Carmichael Coal Mine and Rail Project SEIS

Volume 2 - Mine Studies

13 November 2013

Figure 2
Sheet 1 of 3

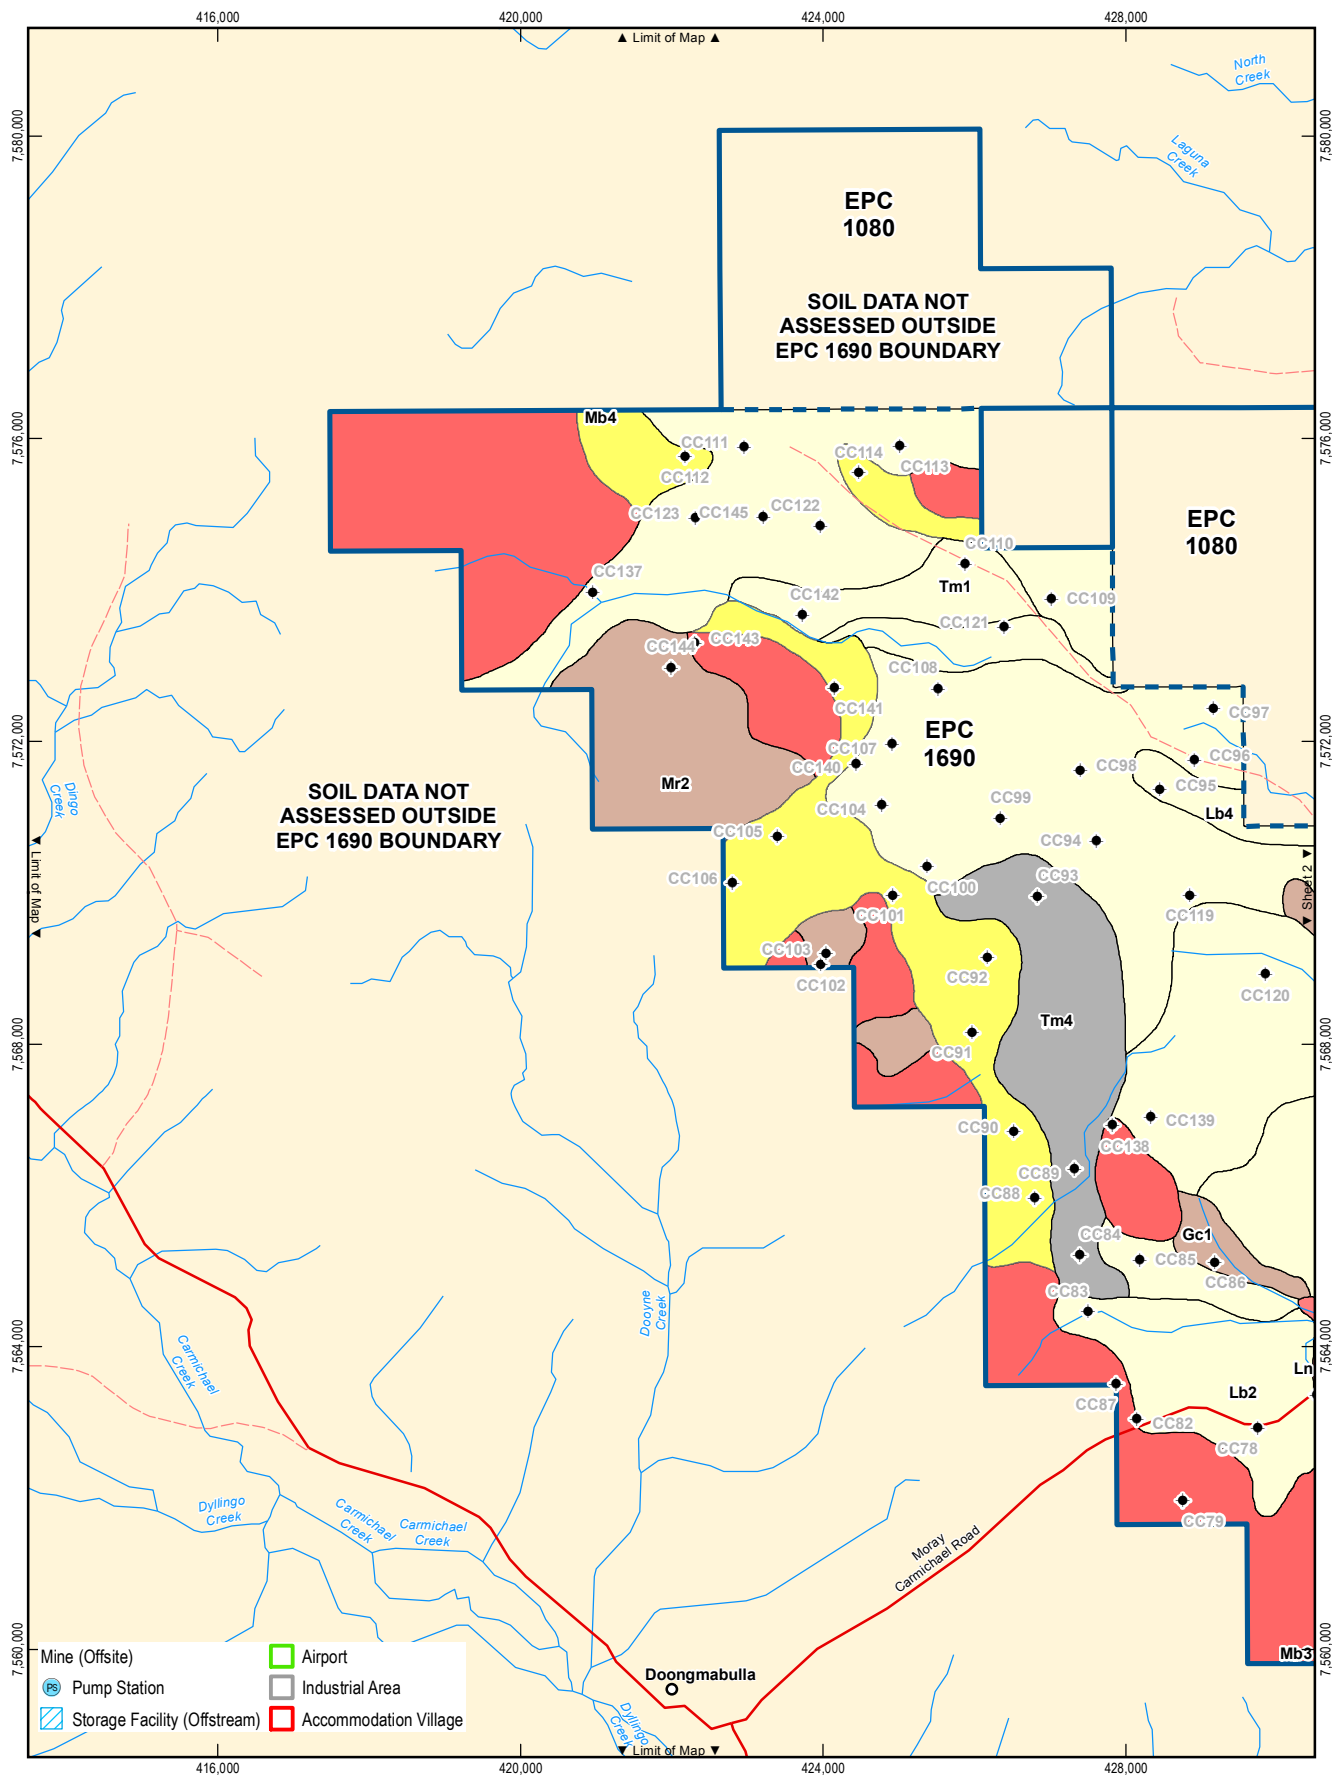
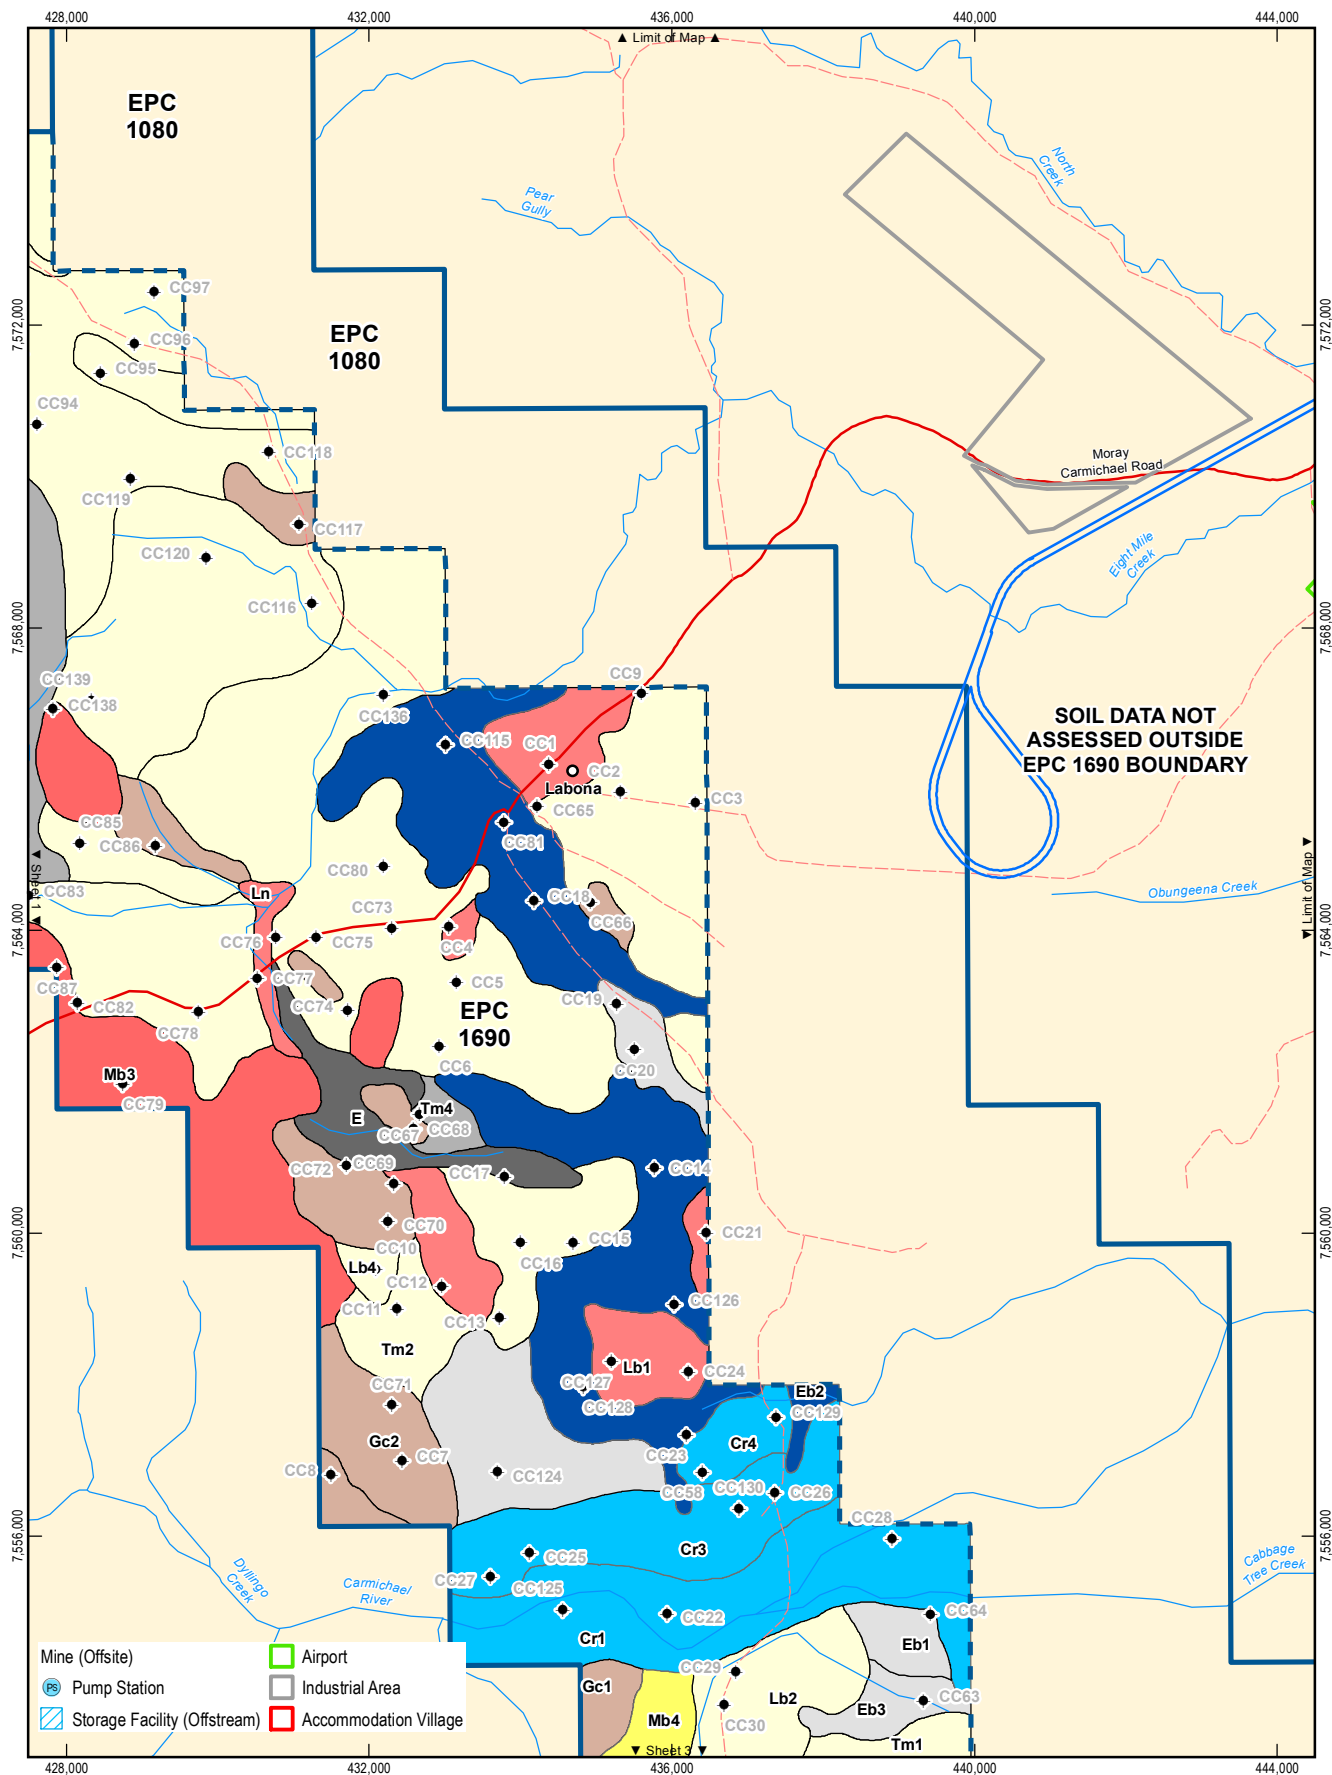
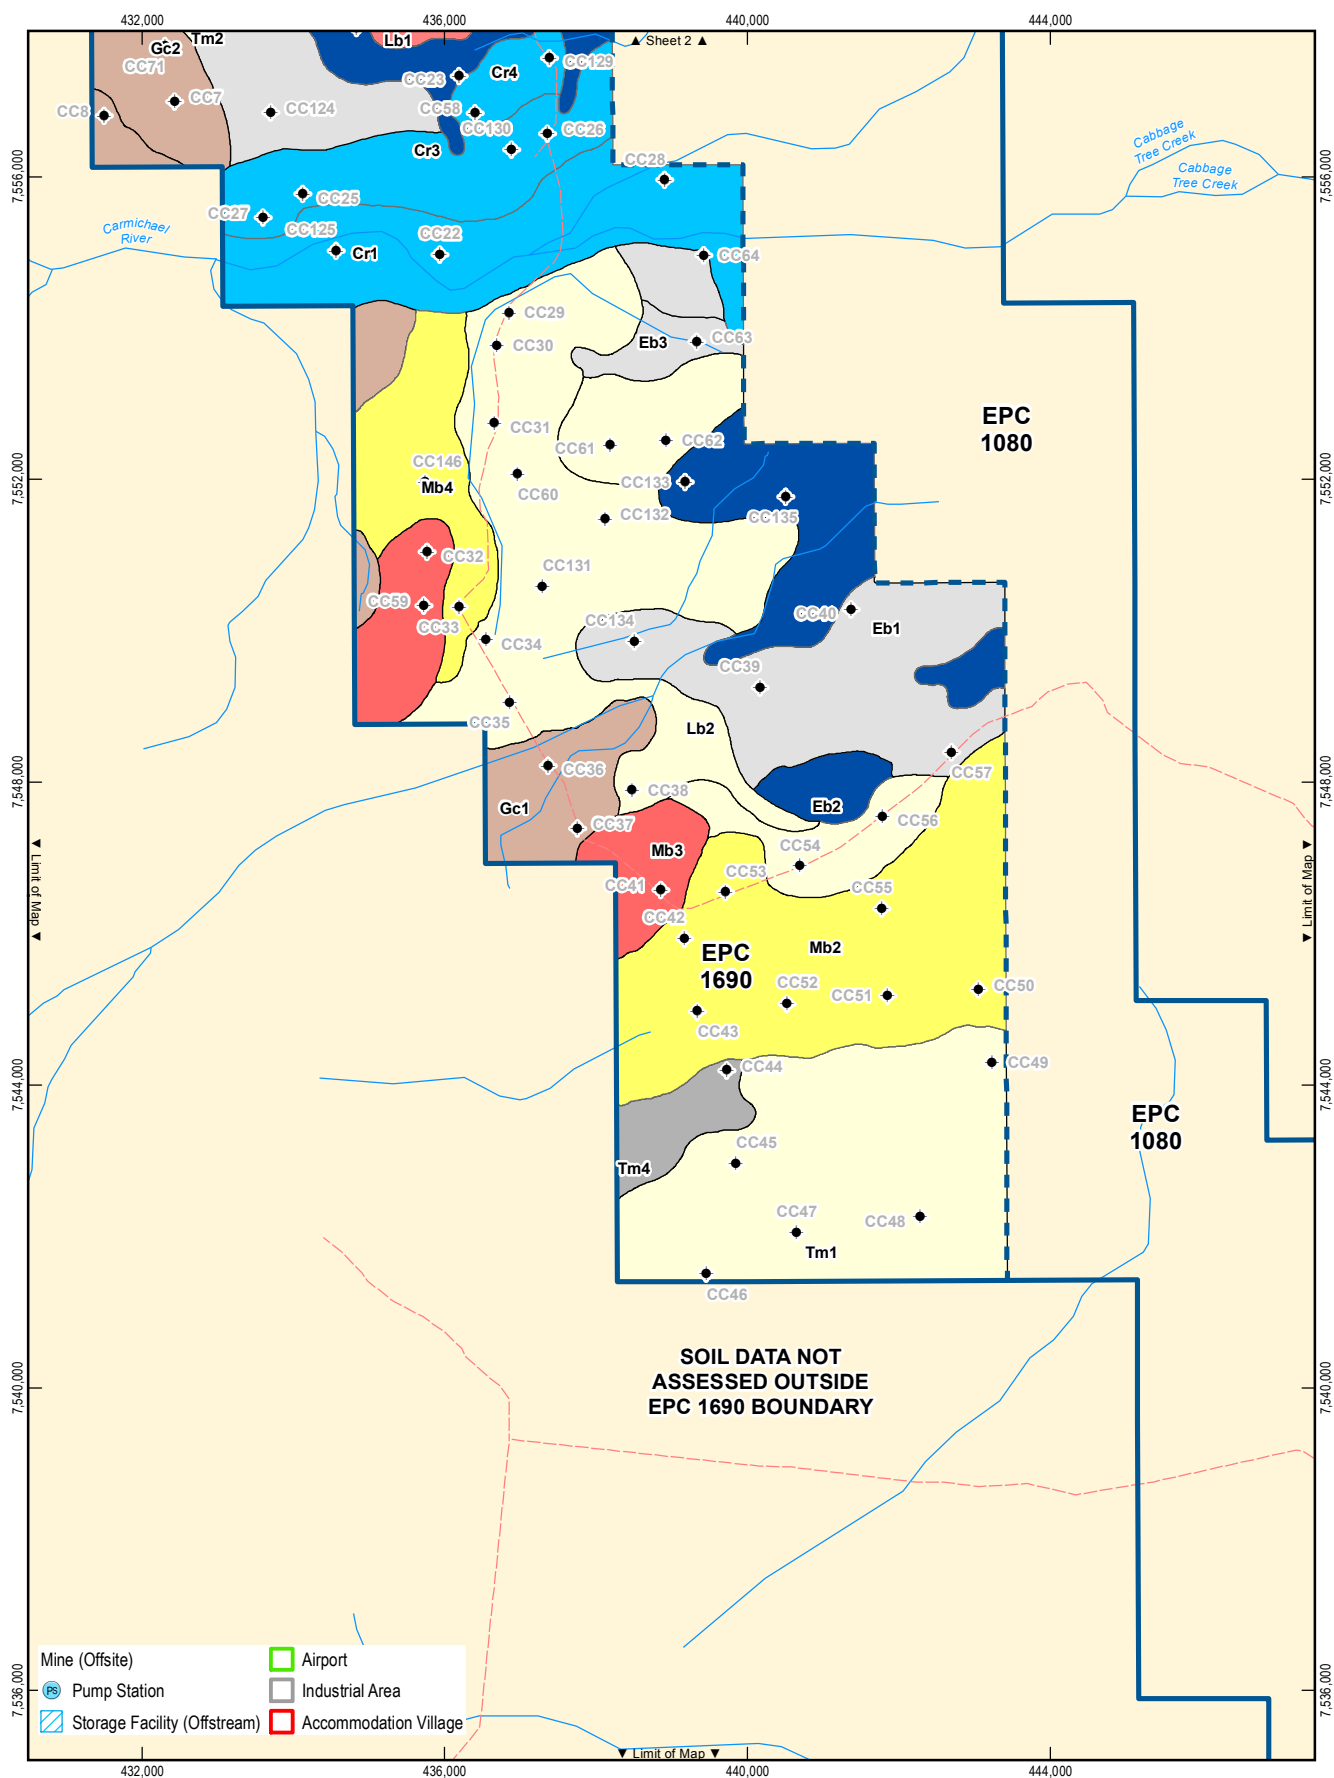
It was requested that the location of boreholes be shown on the soil mapping. The relevant figure has been updated and is provided as Figure 2.
